Date of Issue: March 2013

Affected Publication: API Specification 6A, *Specification for Wellhead and Christmas Tree Equipment*, Twentieth Edition, October 2010

ADDENDUM 3

*Replace **Annex O** in its entirety with the following pages.*

Figure 3 c)

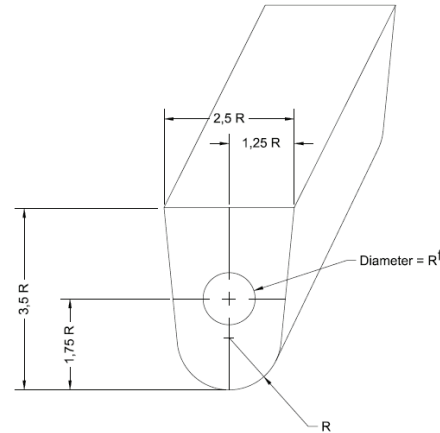
c) Keel block configuration, ER equals 2,3R

Figure 3, footnote f

Replace footnote f with:

“^f This area is the centre core $1/4T$ envelope for test specimen removal.”

Figure 6 — Hardness test locations for weld overlays

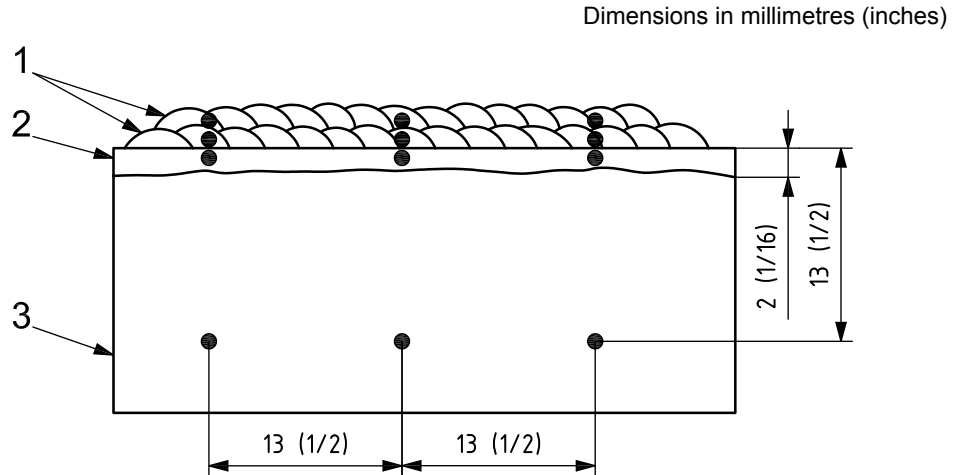
Welds for use in hydrogen sulfide service shall conform to the requirements of ISO 15156 (all parts) (NACE MR0175; see Clause 2). If the welding procedure is to be qualified for use on bodies, bonnets or flanges used for material classes DD, EE, FF or HH, hardness testing shall be carried out by the Rockwell method in accordance with ISO 6508 (all parts) or ASTM E18, or the Vickers 98 N method in accordance with ISO 6507 (all parts) or the Vickers 10 kgf method in accordance with ASTM E92. Hardness tests shall be performed at a minimum of three test locations in each of the base material, the heat-affected zone and in each layer of overlay up to a maximum of two layers. See Figure 6 for required hardness test locations.

**Key**

- 1 overlay
- 2 HAZ
- 3 base
